40 Centre Street Brookline, MA

ZBA Hearing - August 15, 2016

Project Update

Updated Ground Floor Plan

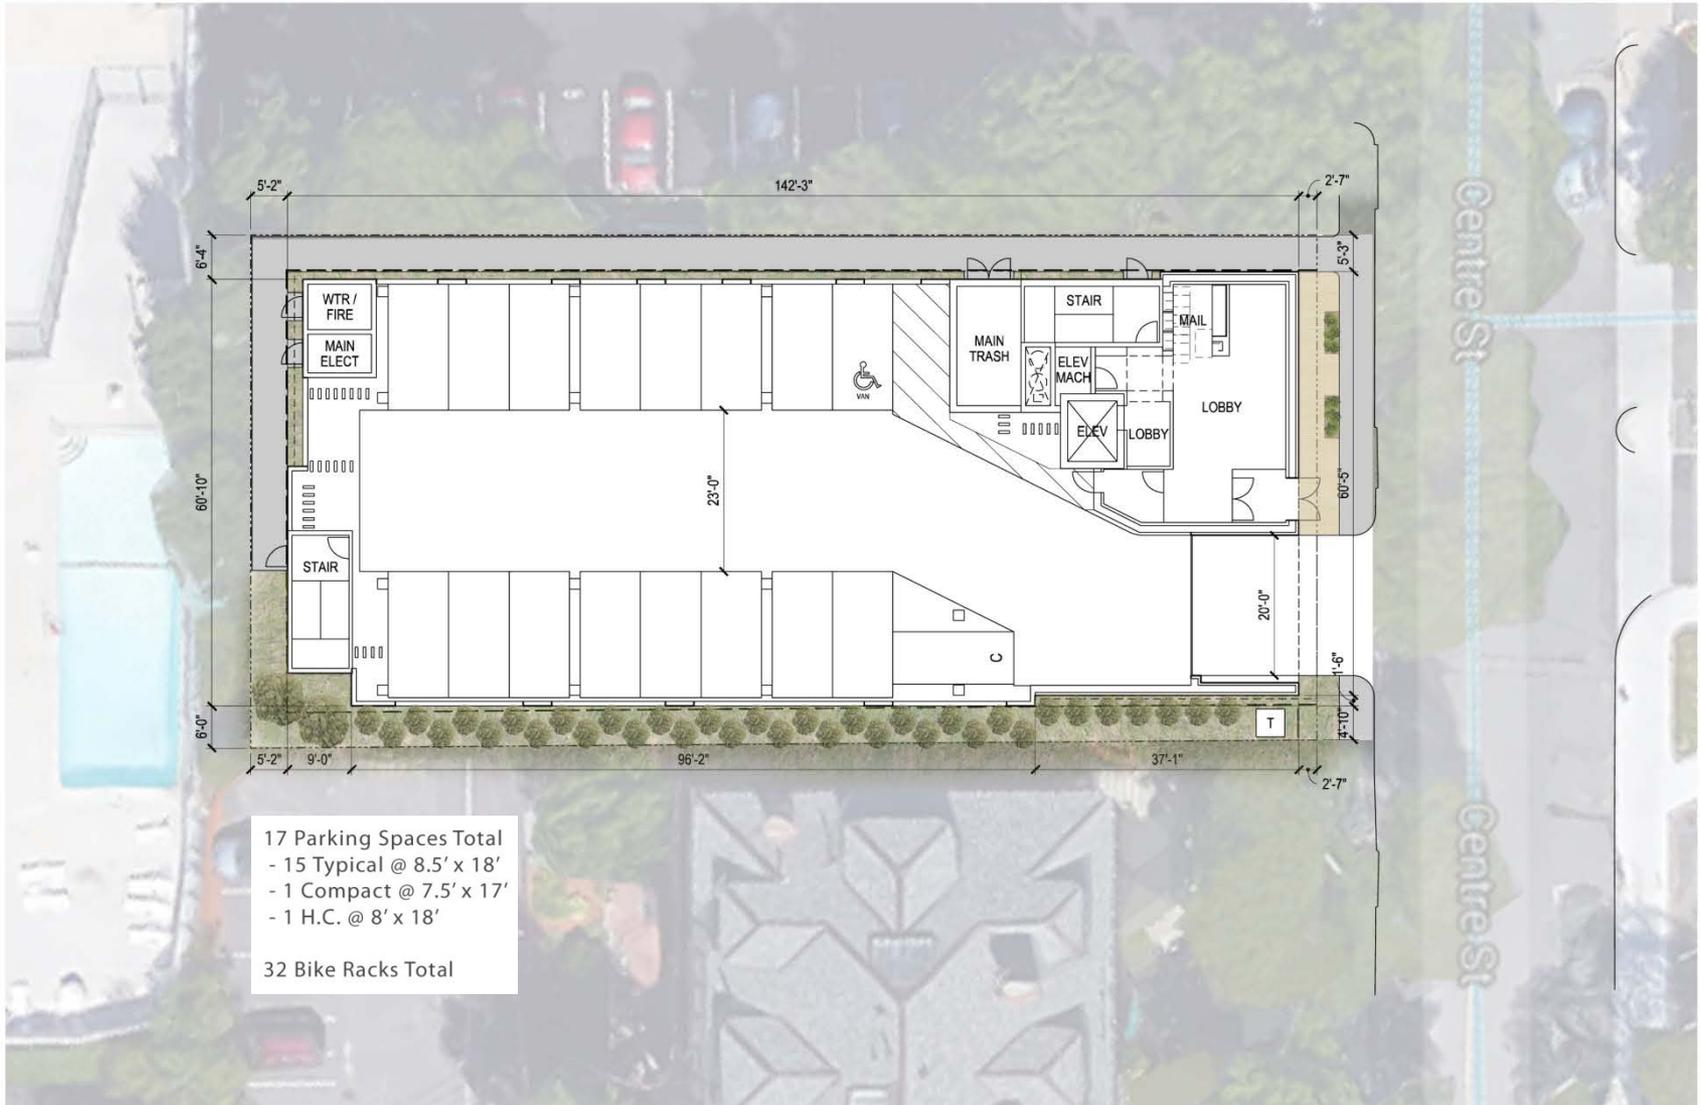
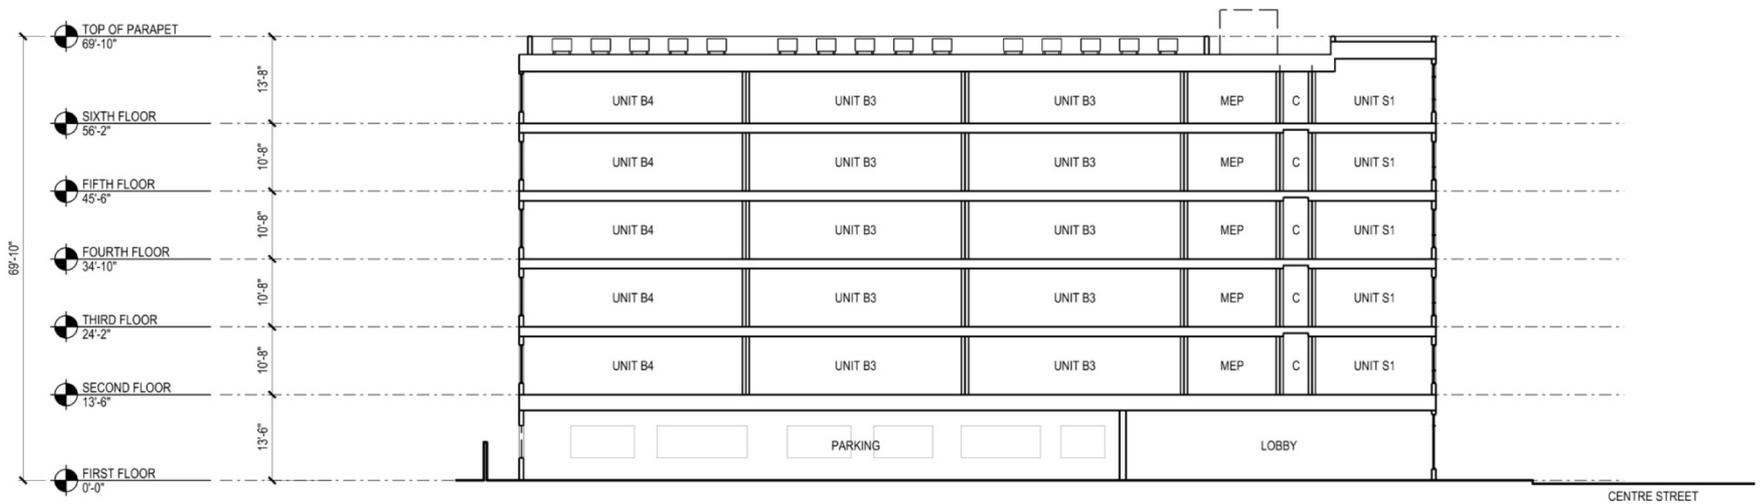
1. Reduced building footprint to provide 15' front yard setback
2. Improved sight lines for vehicles entering/exiting garage
3. Increased vehicle parking capacity
4. Increased bike parking capacity
5. Relocated garage door
6. Identified location for storm water infiltration system
7. Increased storage capacity for trash/recycling
8. Reduced podium floor-to-floor height
9. Improved at-grade open space facing 34 Centre Street
10. Provided direct garage access for pedestrians/cyclists
11. Obtained feedback from key Town staff members
12. Established design guidelines for building design

Revised Ground Floor Plan

Garage Footprint = 7,440 GSF
 18 vehicle parking spaces
 45 bike parking spaces

15' setback
